Plant Name:  
Three Mile Island #1

Three Mile Island Nuclear Station Unit No. 1  
Docket Number 50-289

RESPONSES TO QUESTIONS RAISED IN ENCLOSURE 2

CONCERNING APPENDIX I

FIGURE 8-1

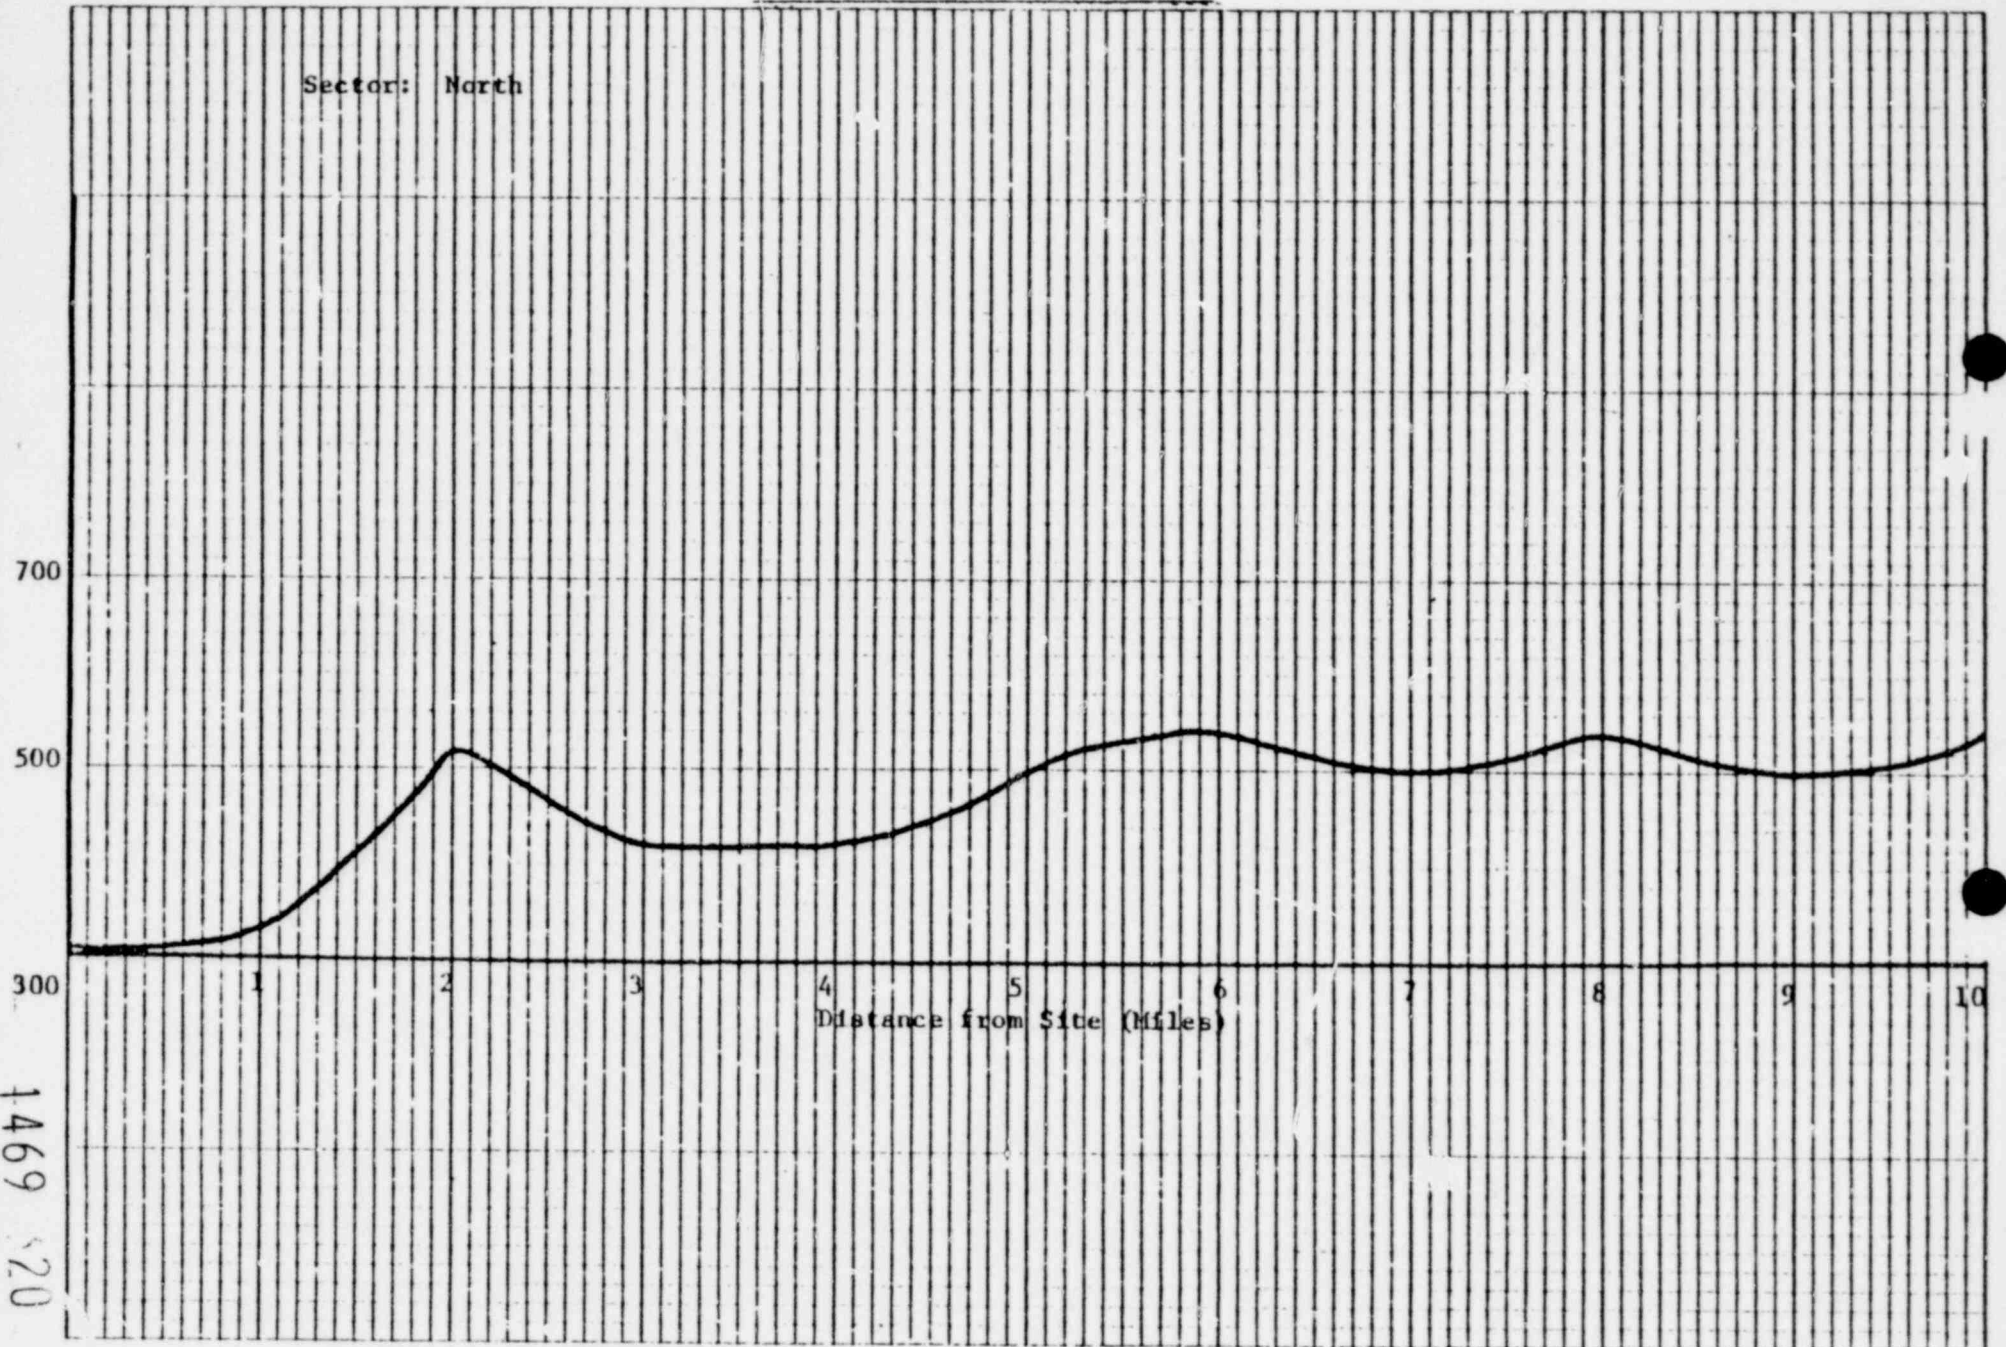
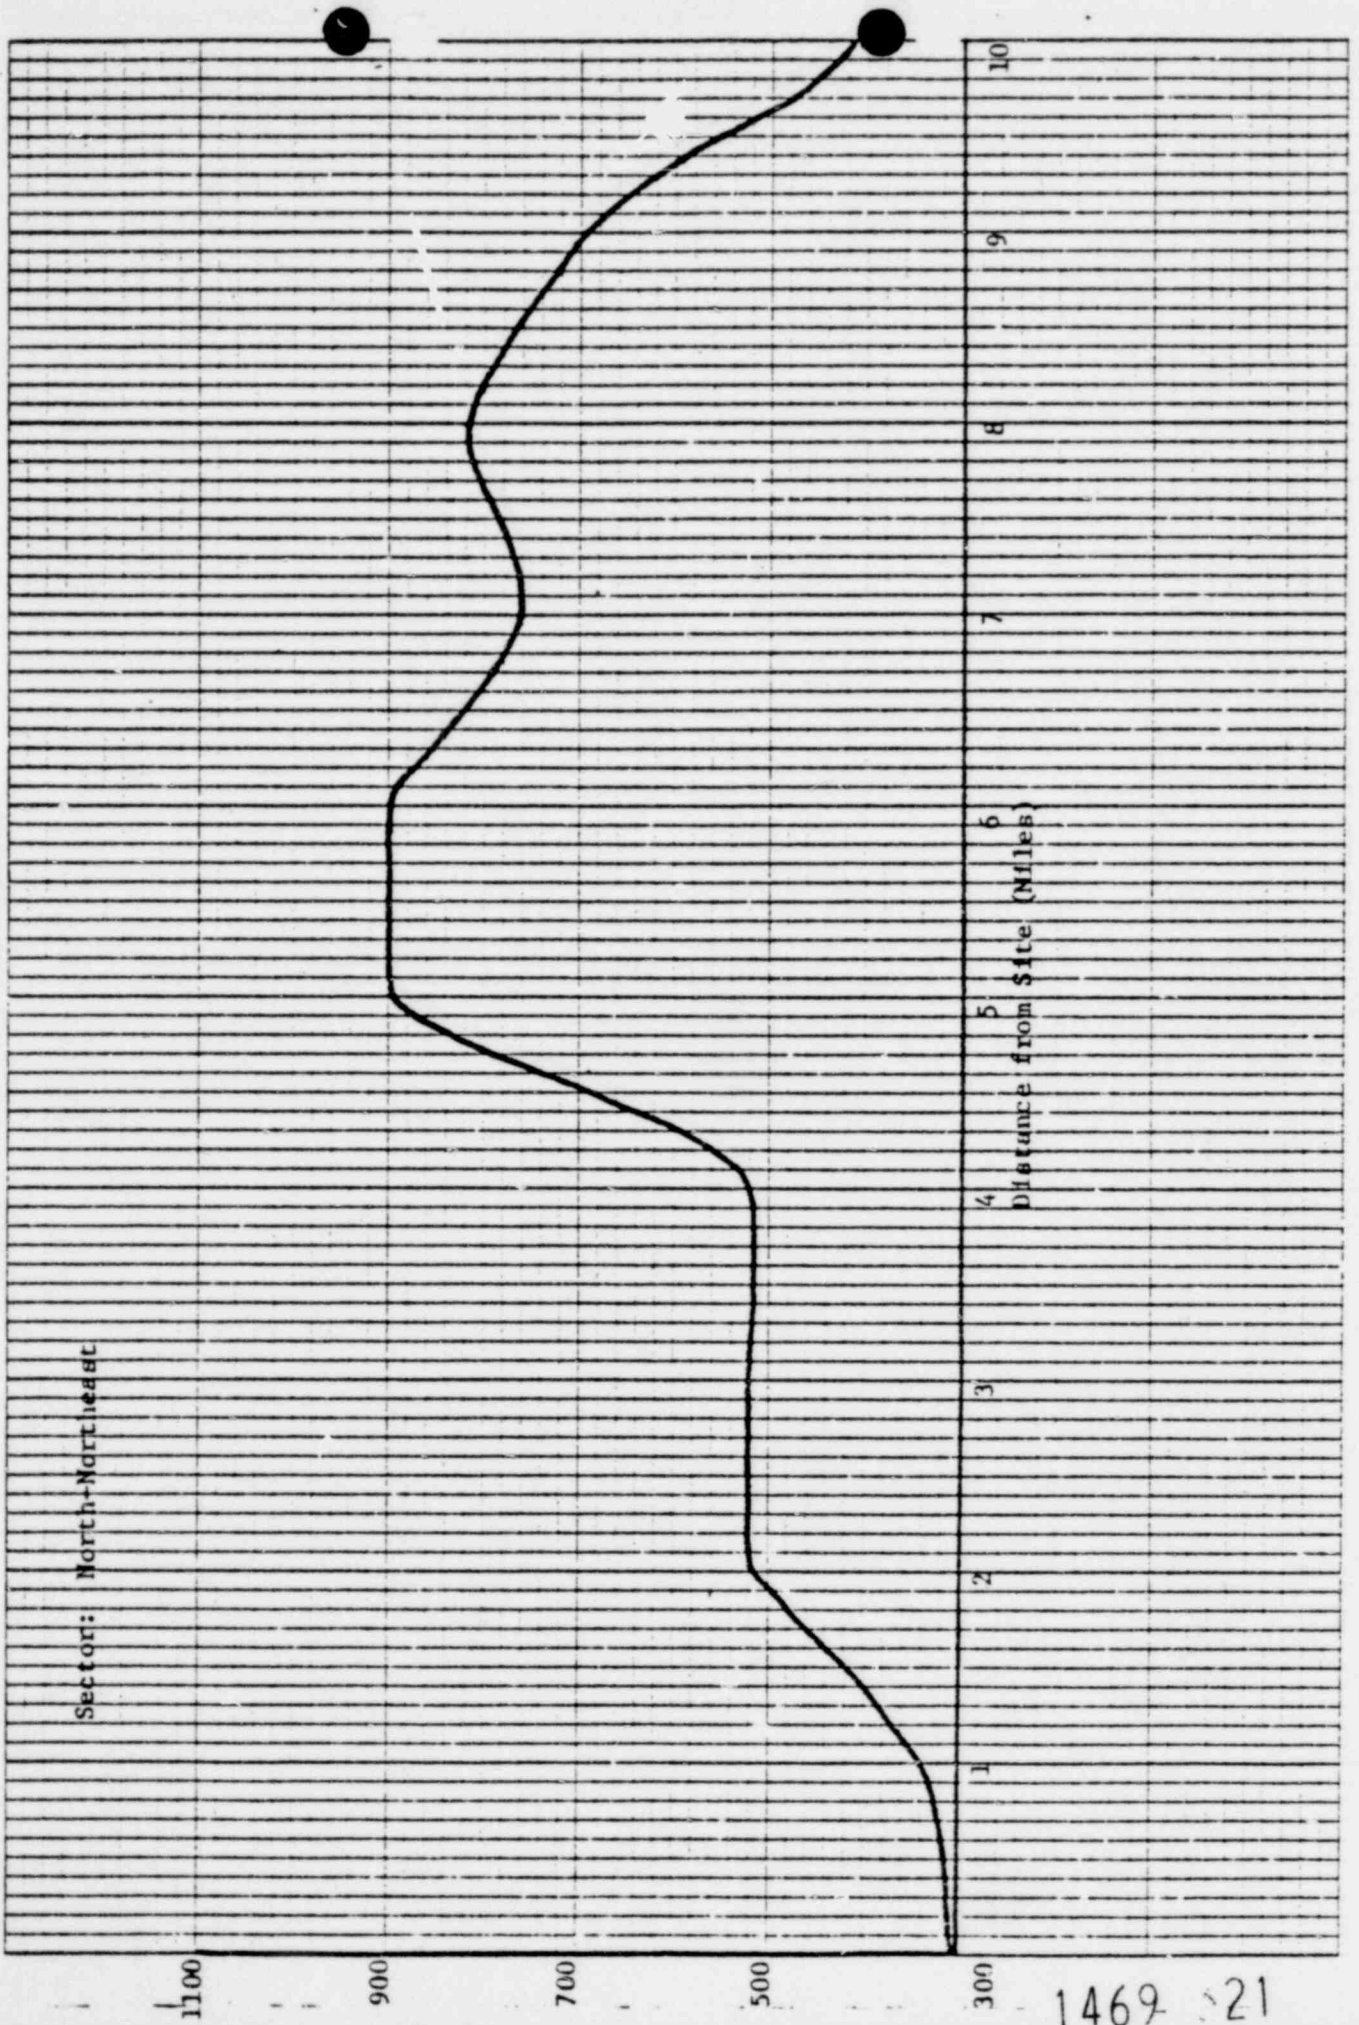
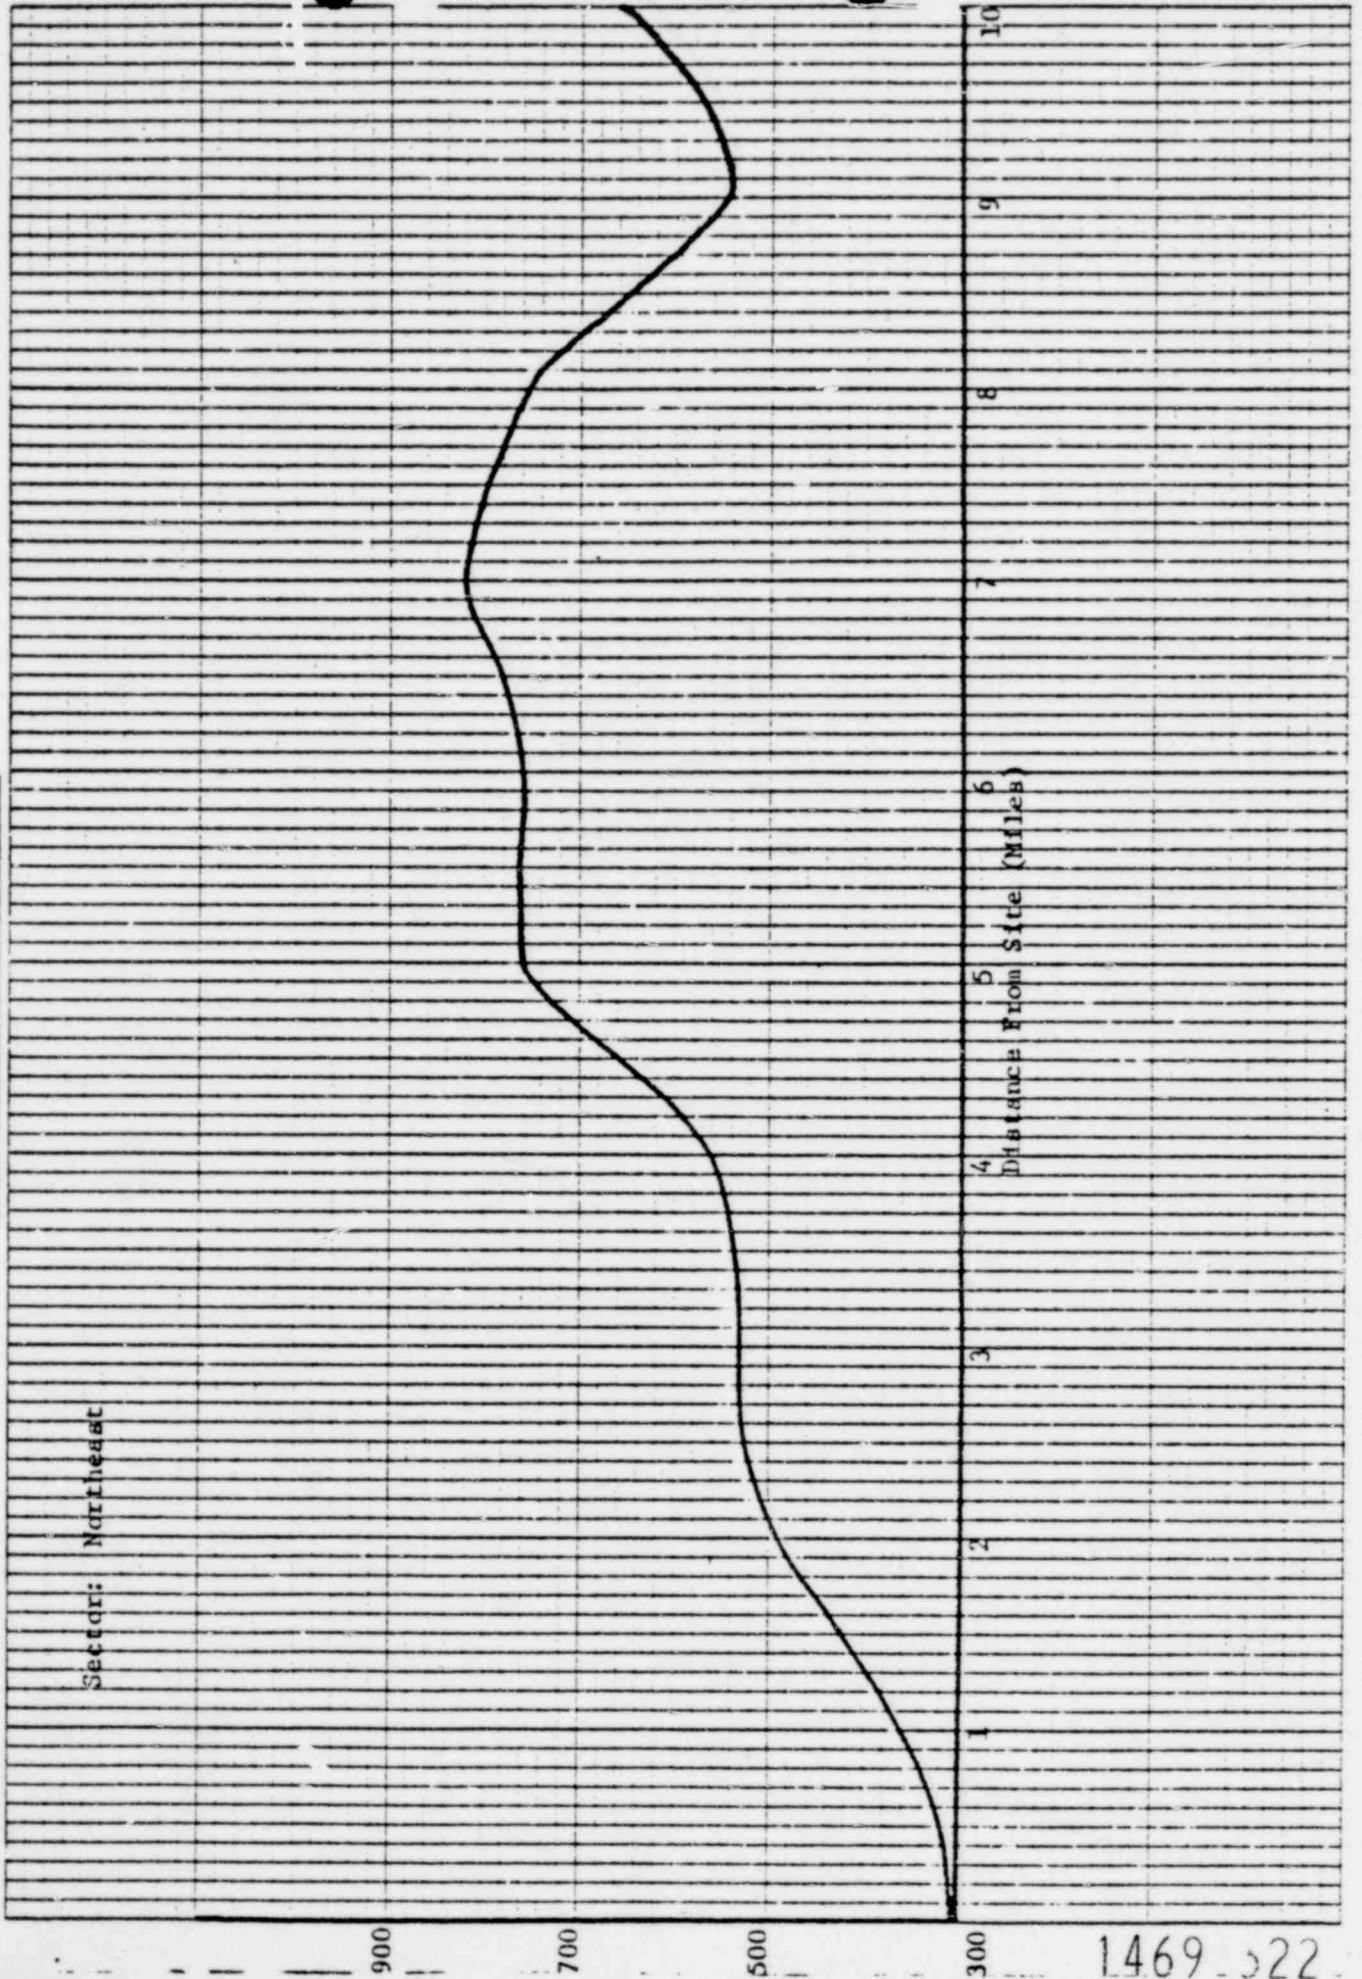
Provide a map showing the detailed topographical features (as modified by the plant) on a large scale, within a 10-mile radius of the plant and a plot of the maximum topographic elevation versus distance from the center of the plant in each of the sixteen 22-1/2 degree cardinal compass point sectors (centered on true north), radiating from the center of the plant, to a distance of 10 miles.

See attached Table 8-1 and Figures 8-1 through 8-16.
